APPEAL SUMMARY

Appeal ID: 14920	Project Address: 4732 N Albina Ave
Hearing Date: 4/12/17	Appellant Name: Martha Williams
Case No.: P-002	Appellant Phone: 503-946-6694
Appeal Type: Plumbing	Plans Examiner/Inspector: to be determined
Project Type: commercial	Stories: 4 Occupancy: not provided Construction Type: not provided
Building/Business Name:	Fire Sprinklers: Yes - not provided
Appeal Involves: Erection of a new structure	LUR or Permit Application No.: 17-112866-CO
Plan Submitted Option: pdf [File 1] [File 2] [File 3]	Proposed use: Multi-Family Apartments

ALBINA APARTMENTS
4734 N. ALBINA AVE.
PORTLAND, OR 97217

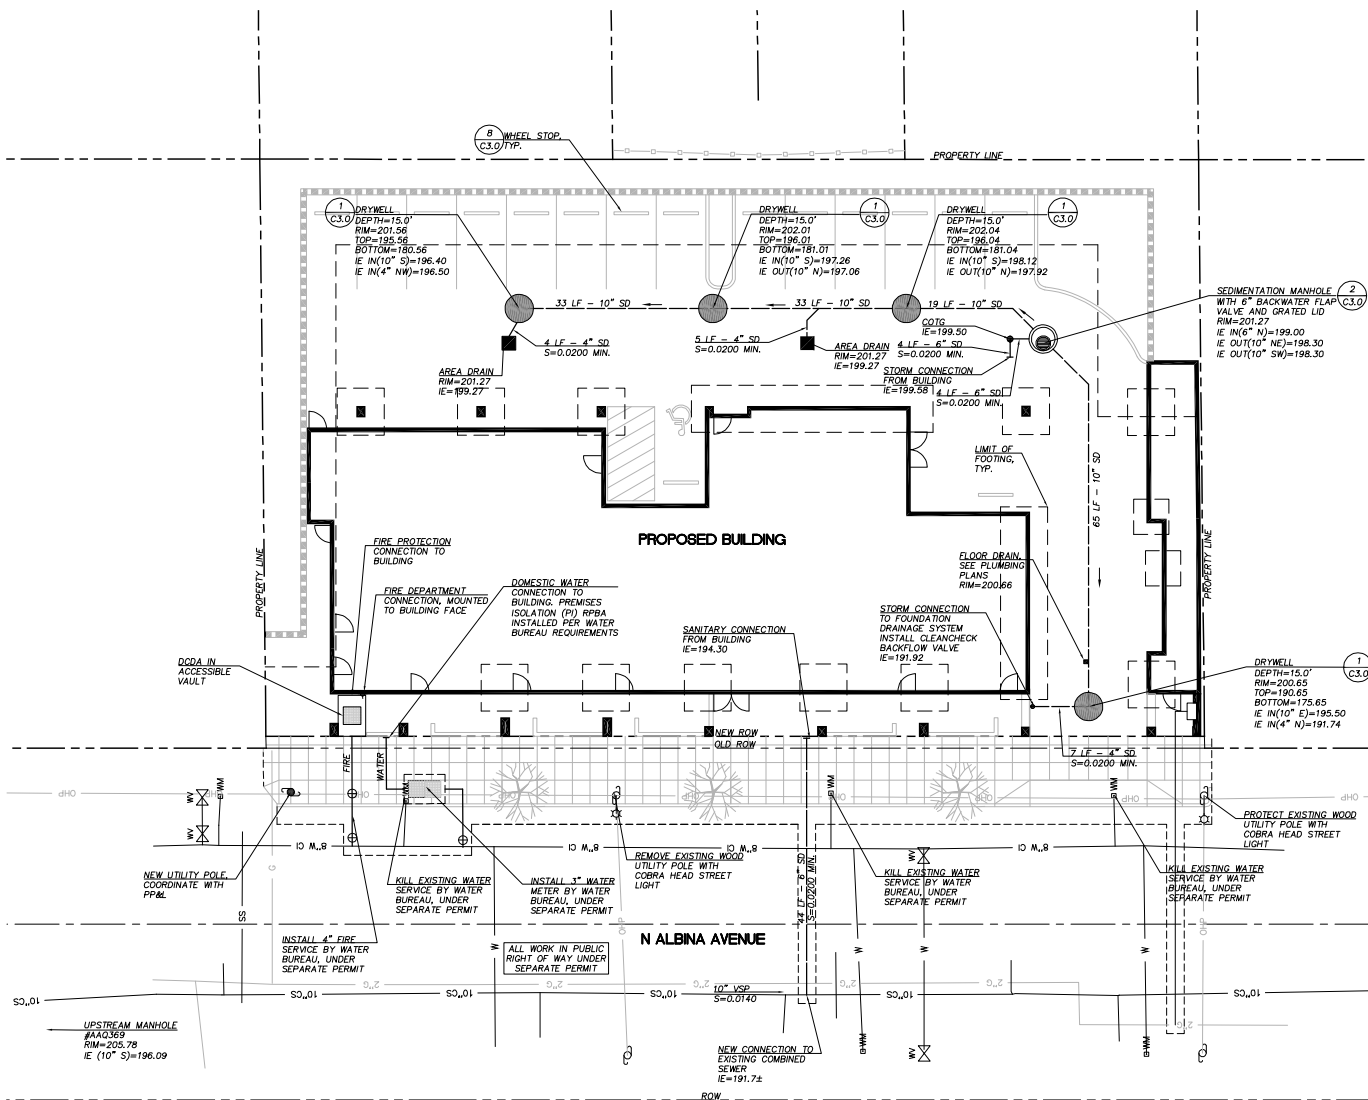
The bearing capacity of the footings will not significantly be affected by the by the proposed drywell, as explained in the attached memo from GeoDesign Inc, dated March 17, 2017.

Reduced setbacks for drywells: Denied.

UTILITY PLAN

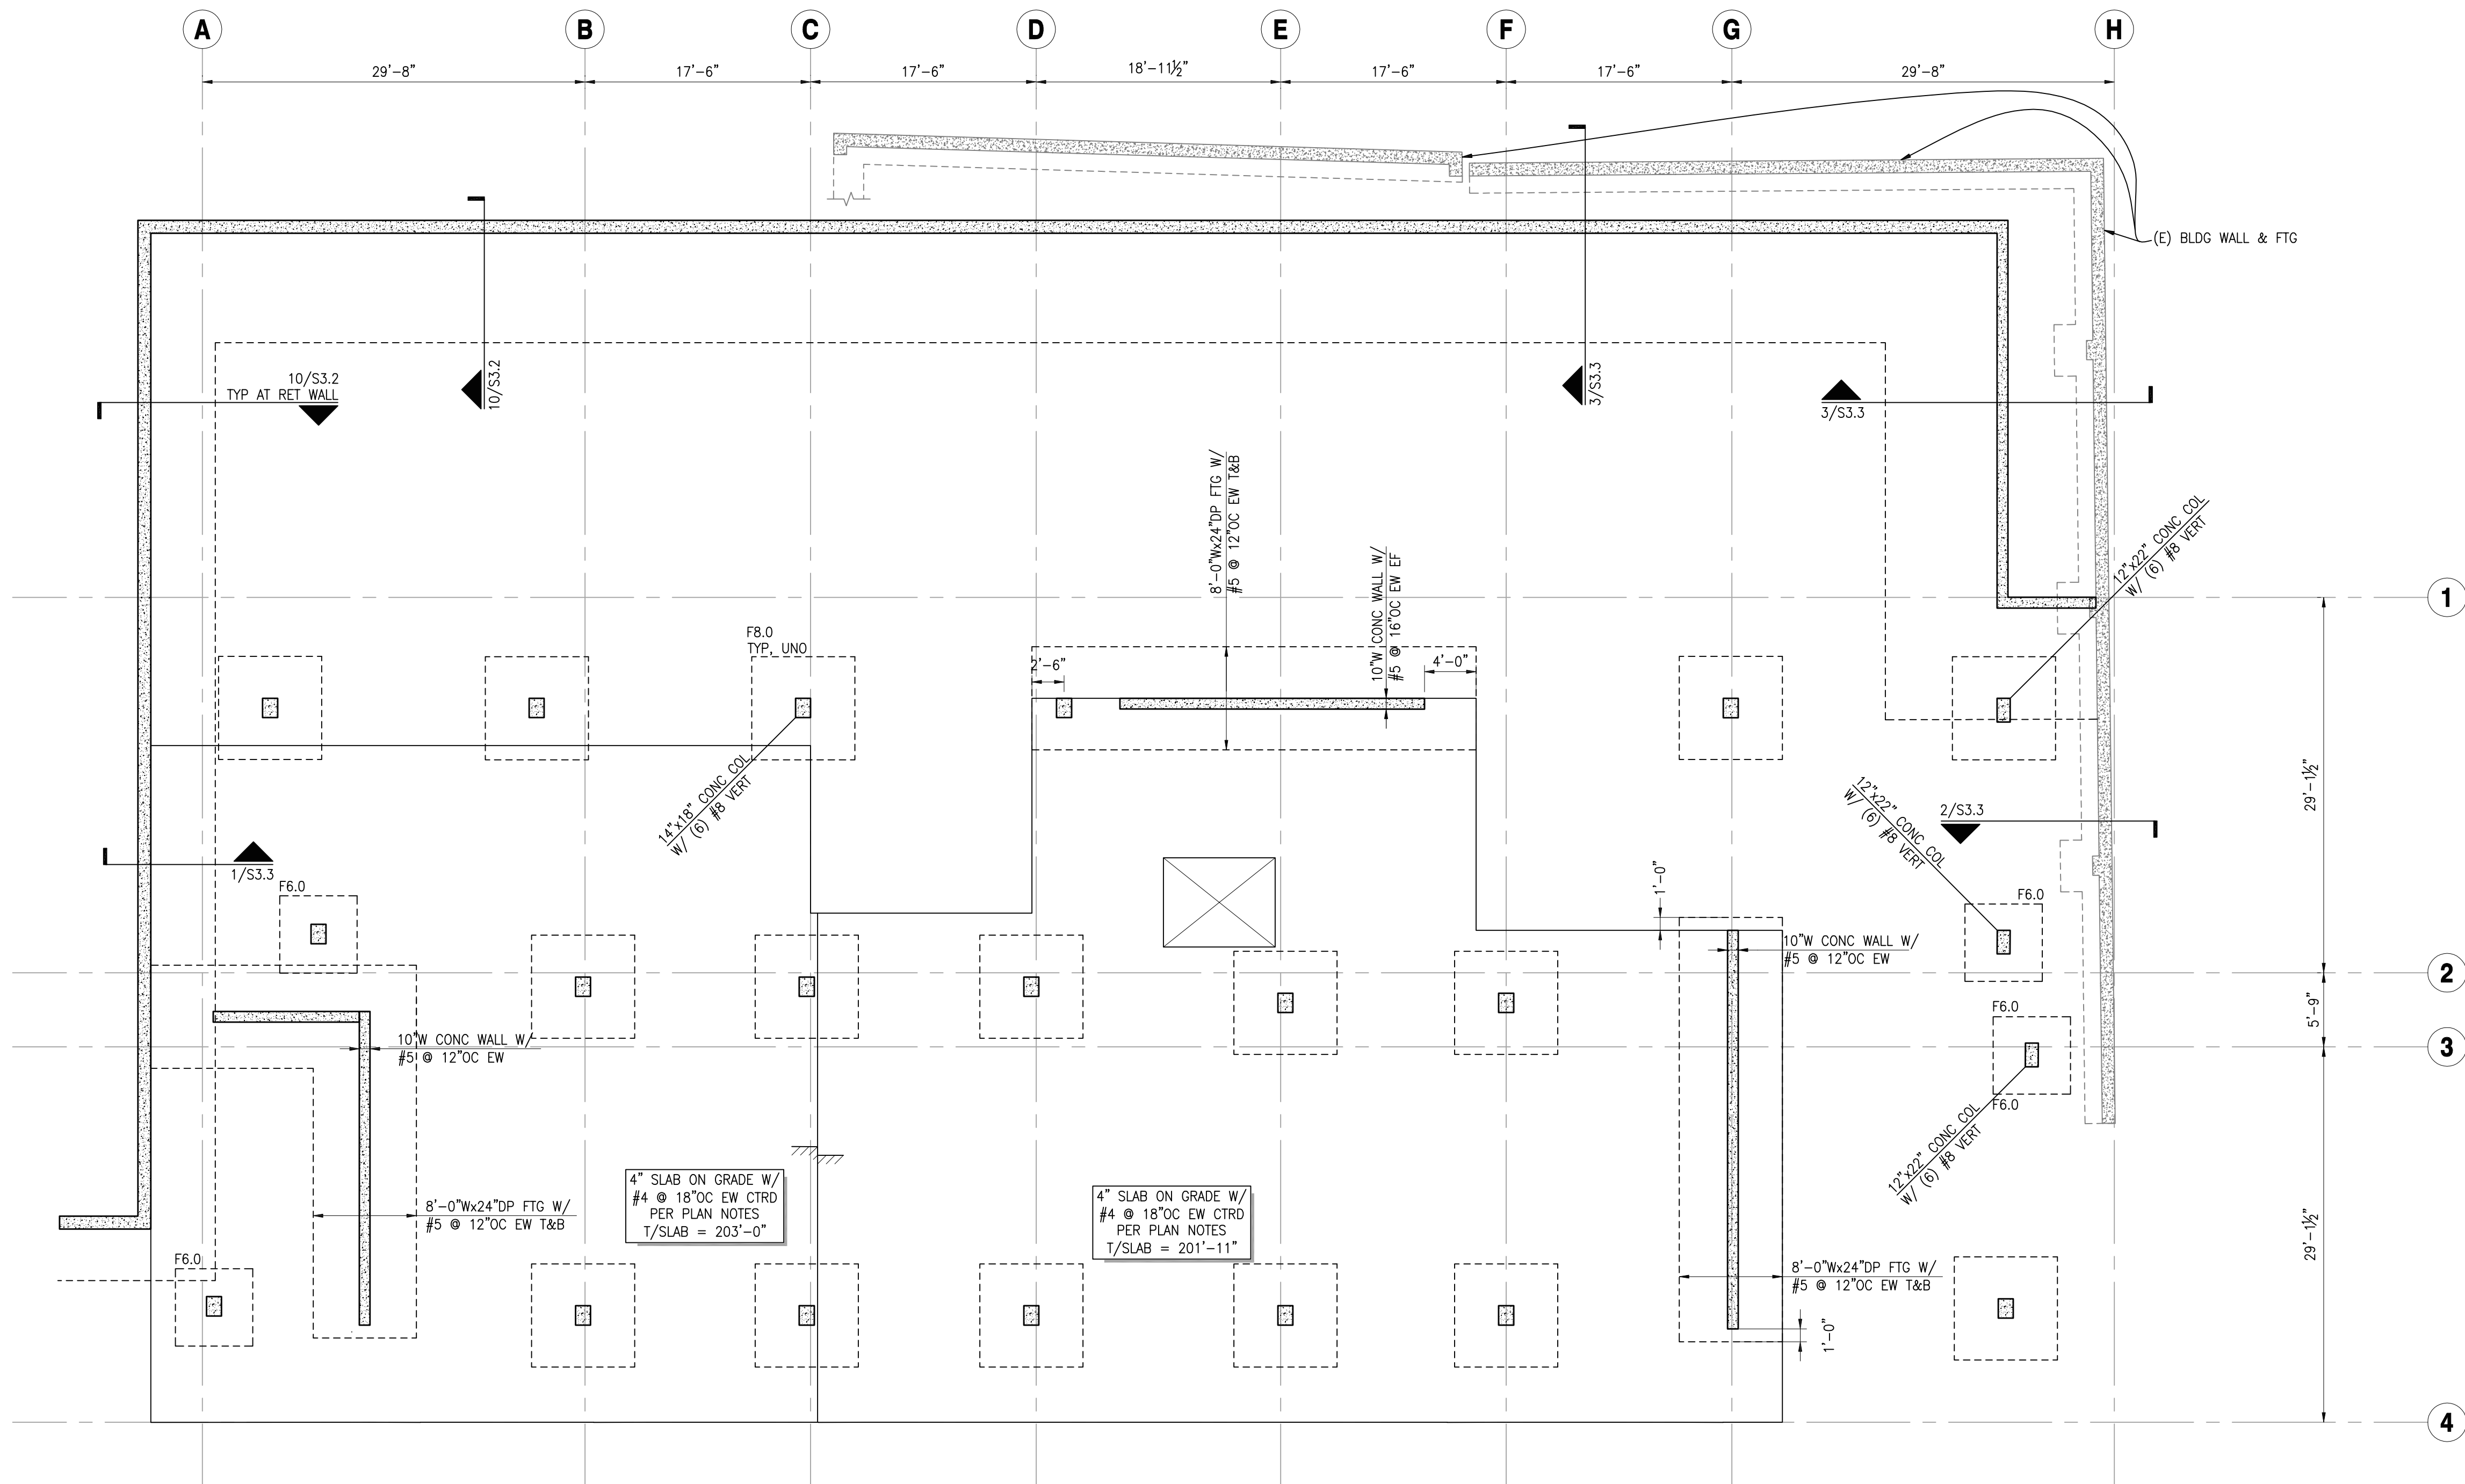
Code Section	Oregon Plumbing Specialty Code - Storm Drainage 1101 .5.3.2
Requires	2016 Portland Stormwater Management Manual - Chapter 2.3.4.15, Drywells, Design Requirements, Setbacks Pg 2-118.
Proposed Design	<p>The applicant is proposing the use of a drywell system to be installed in the open air parking lot adjacent to the new building. One of the drywells in the system will be located within 10 feet of the structure in order to provide an escape route in the event that a large storm event occurs, see 'Reason for Alternate' section for more information. The proposed drywell design has been reviewed by the Geotechnical Engineer per attached memorandum.</p> <p>The drywell system proposed for the building was sized to infiltrate the 10-year storm and was designed with an escape route to safely drain stormwater away from structures during large storm events. The sizing of the drywell systems was done using HydroCAD®. A design infiltration rate of 2 in/hr was used for calculations, see attached Stormwater Report. The drywell system will be tested at the time of installation to verify infiltration capacity.</p> <p>Feasibility of on-site infiltration:</p> <p>The feasibility of the drywell system location is based on infiltration testing, maintenance, structural design and strength of soils. Infiltration testing was performed by GeoDesign, Inc. and documented in the "Report of Geotechnical Engineering SeNices" dated July 22, 2016. This report shows measured infiltration rates of 4 in/hr onsite at a depth of 15.5 feet. The drywells are deep and will be discharging stormwater 7-22 feet below the bottom of the adjacent footings, which equates to 10-25 feet below grade. The infiltration rate of the deep soils will prevent saturation of the shallow soils directly underneath the buildings. See attachments for supporting data on the effectiveness of infiltration for the site.</p>

Reason for alternative	The applicant proposes that one drywell in the system be installed approximately 7 feet from adjacent footings in order to achieve safe overland flow in the event of a major storm event. As a

result, the drywell will not be in accordance with the OPSC.

LEVEL 1 FOUNDATION & MILD REINFORCING PLAN

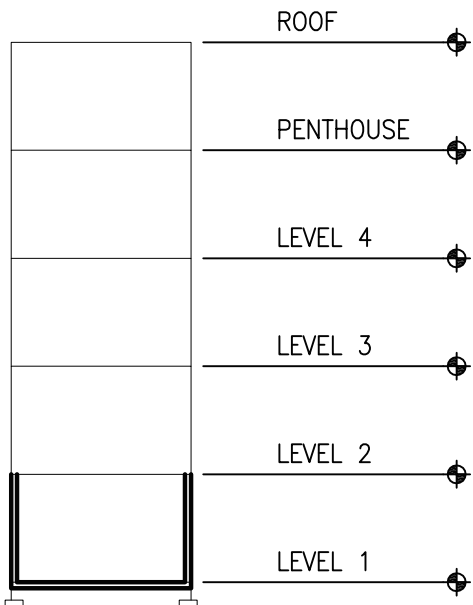
Based on our review of the information provided, the proposed dry wells will not significantly affect bearing capacity of the footings. We recommend that the project structural engineer also review the proposed dry well design to verify they have sufficient structural capacity to resist surcharge loads from the adjacent footings.
